Gregory Canyon Creek Mitigation Study

Summary of Public Comments Received

Gregory Canyon Creek Flood Mitigation Study
March 30, 2015 Open House
March - April 2015 Online Questionnaire
Public Comments

Gregory Creek Channel and Culvert Improvements at Euclid Avenue

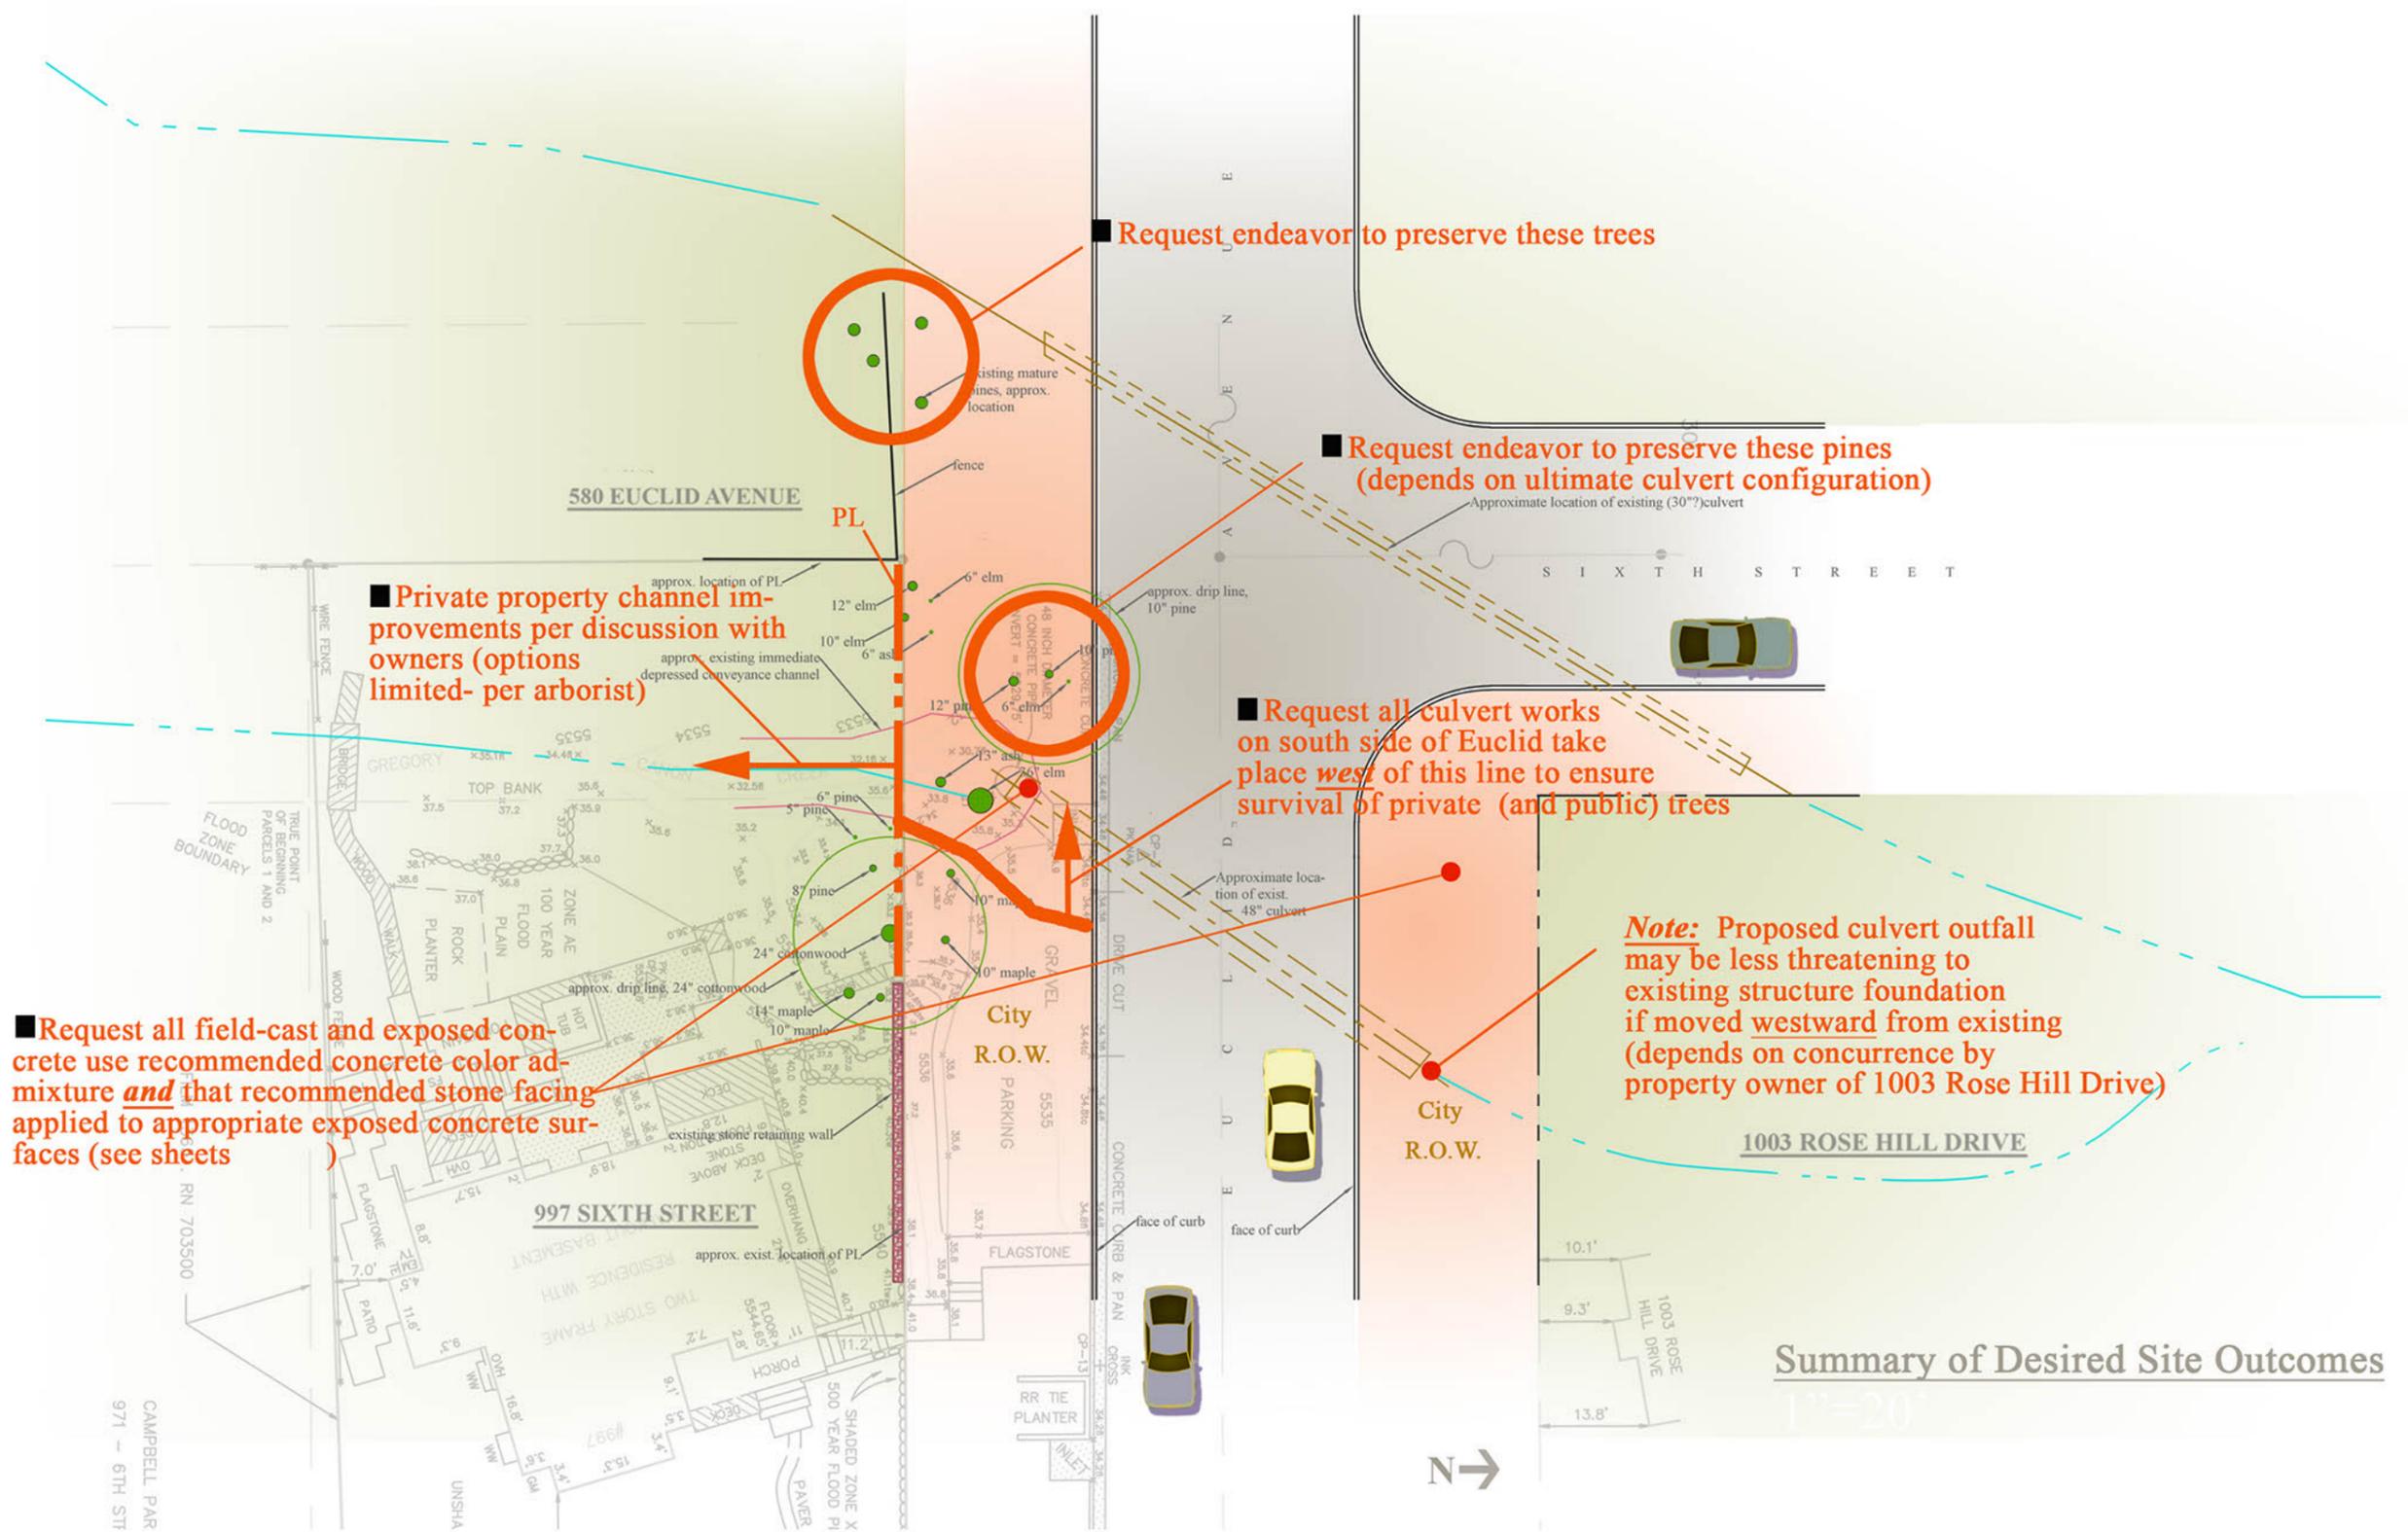
Request endeavor to preserve these trees

Request endeavor to preserve these pines (depends on ultimate culvert configuration)

Private property channel improvements per discussion with owners (options limited- per arborist)

Request all culvert works on south side of Euclid take place west of this line to ensure survival of private (and public) trees

Summary of Desired Site Outcomes

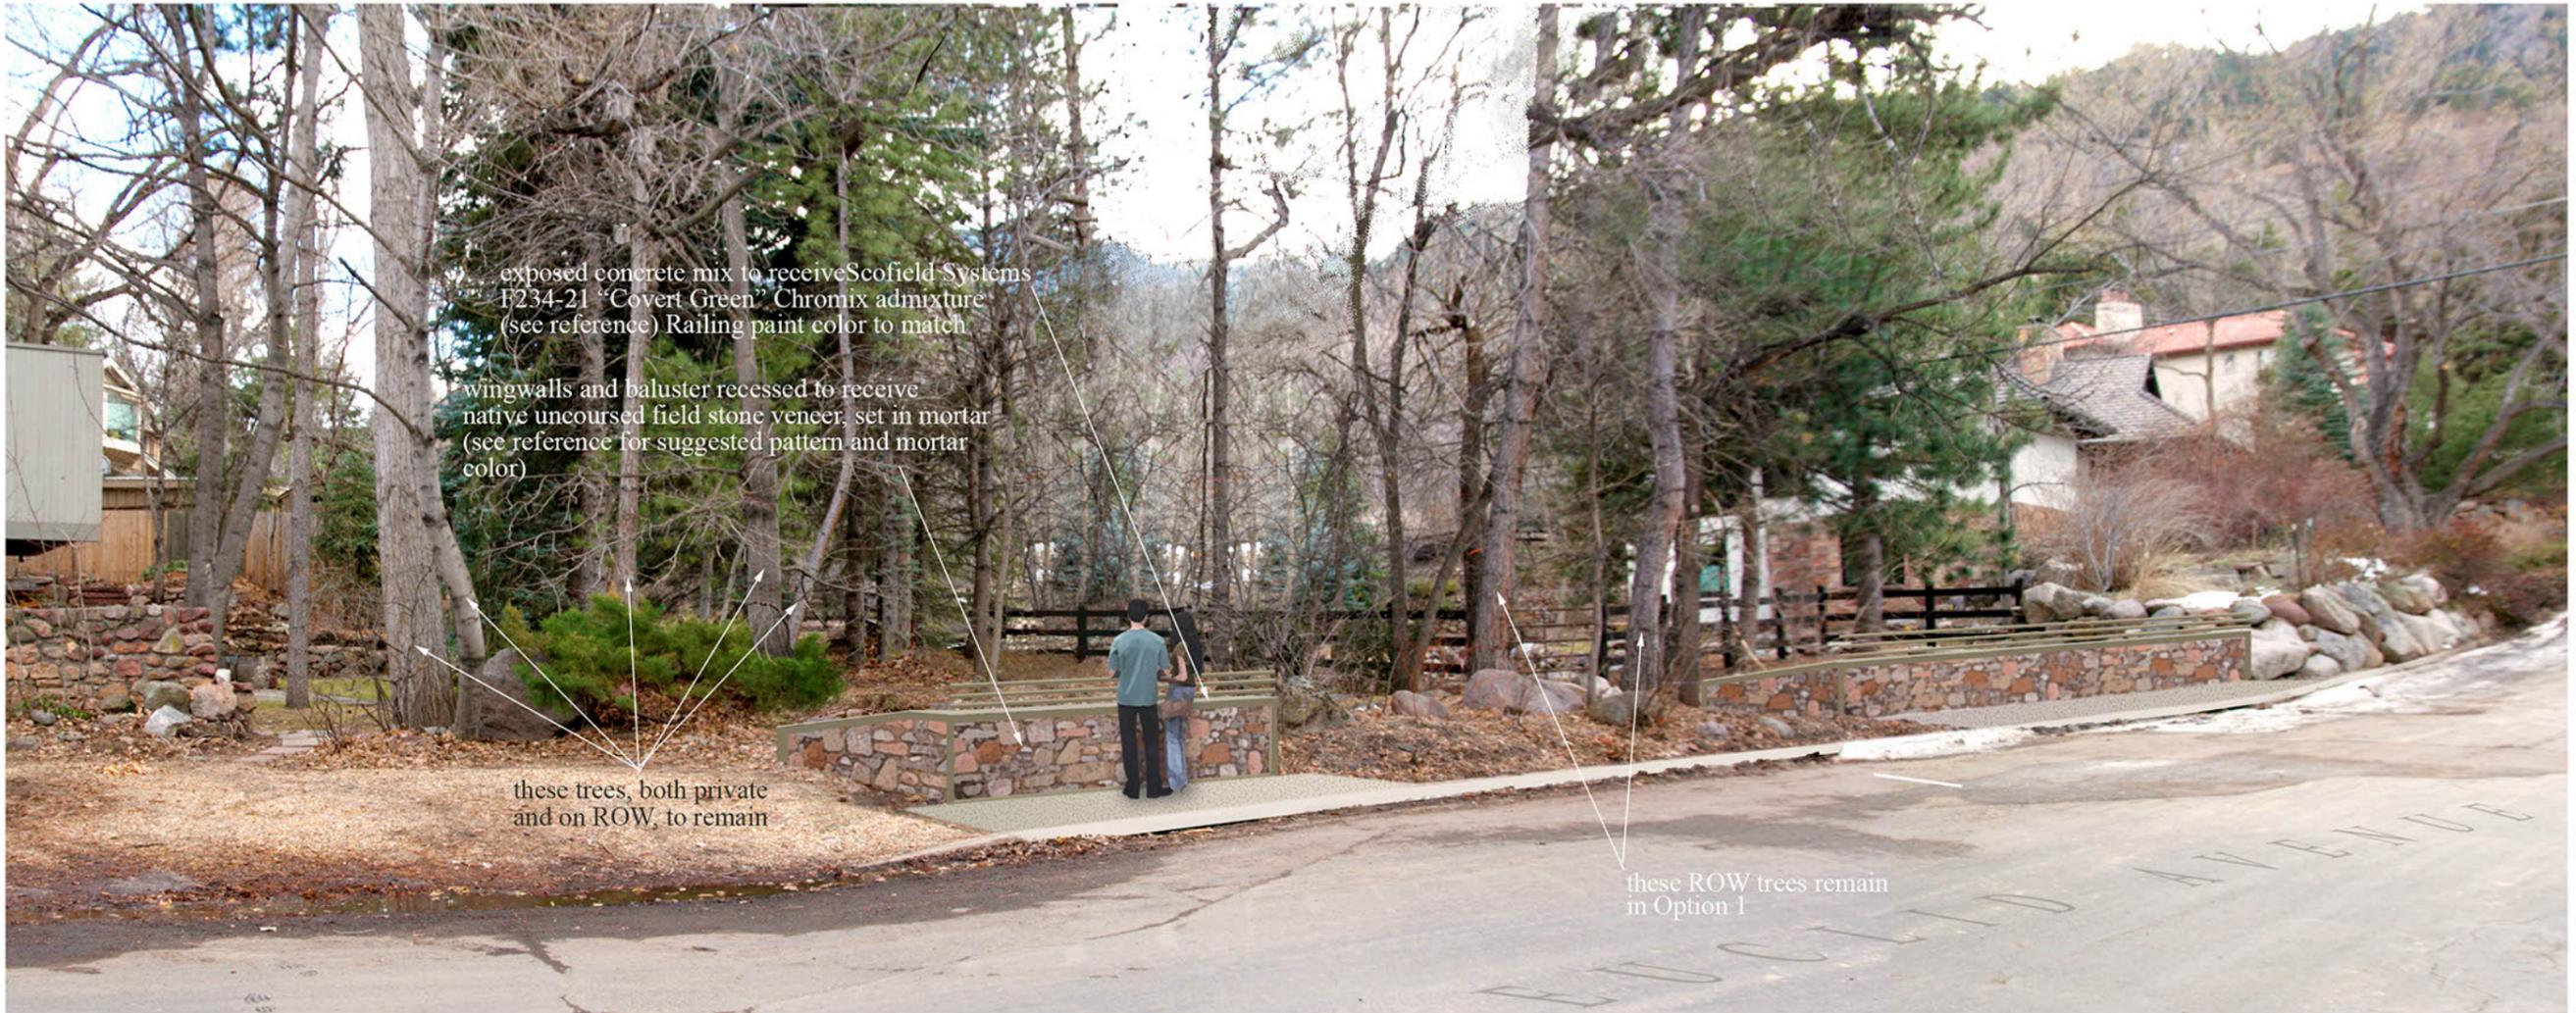
Request all field-cast and exposed concrete use recommended concrete color admixture and that recommended stone facing applied to appropriate exposed concrete surfaces (see sheets)

Note: Proposed culvert outfall may be less threatening to existing structure foundation if moved westward from existing (depends on concurrence by property owner of 1003 Rose Hill Drive)

exposed concrete mix to receive Scofield Systems F234-21 "Covert Green" Chromix admixture (see reference) Railing paint color to match

wingwalls and crown recessed to receive native uncoursed field stone veneer, set in mortar (see reference for suggested pattern and mortar color)

existing conveyance channel *could* be revised per plan upon discussion with property owners; seed with indigenous grasses

Requested Finishes at Culvert : Crowns, Balustrades, and Wing Walls

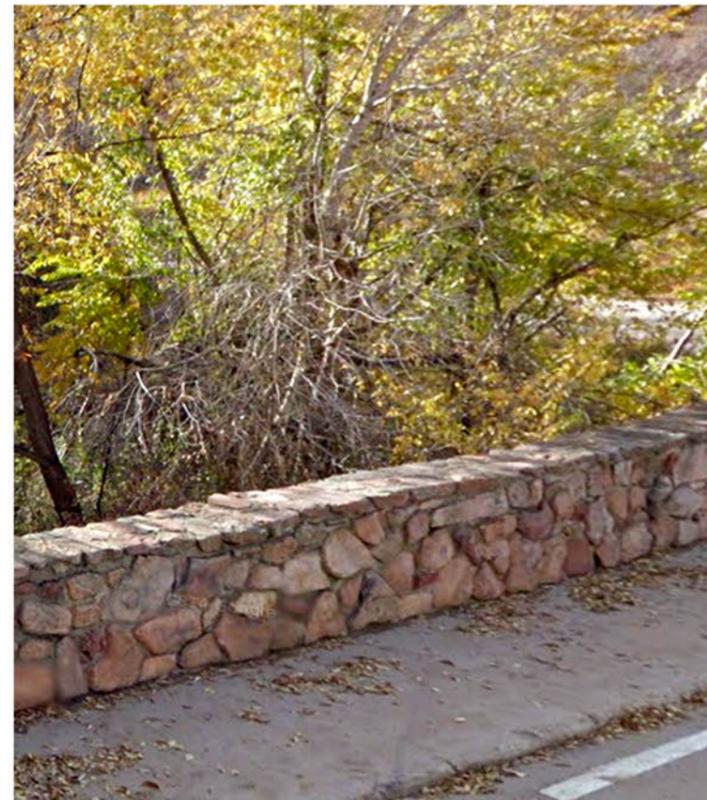
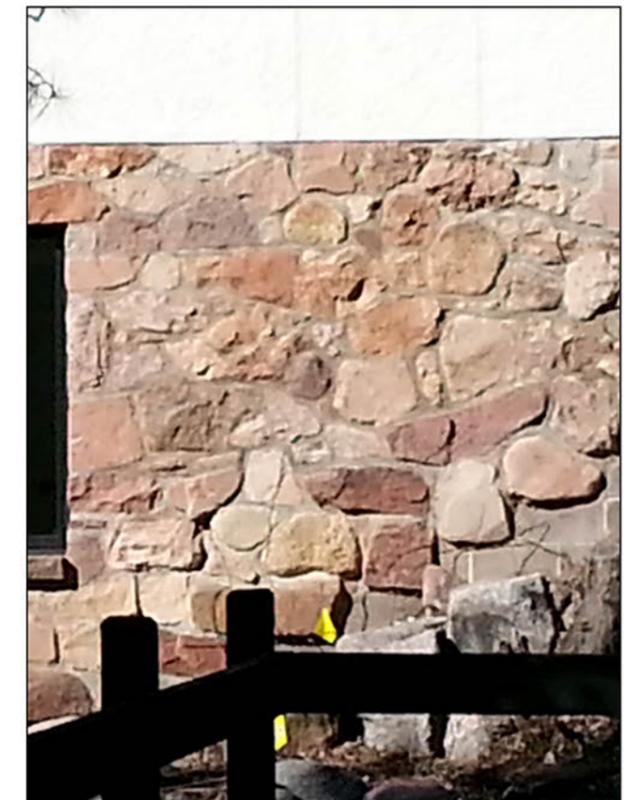
Note: We request this proposed intervention on Gregory Creek and the neighborhood use finishes that help to mitigate its visual impacts and relate it to its context. To that end, we recommend using a color admixture for exposed concrete surfaces and indigenous uncoursed native fieldstone veneer similar in size and shape to the examples shown here
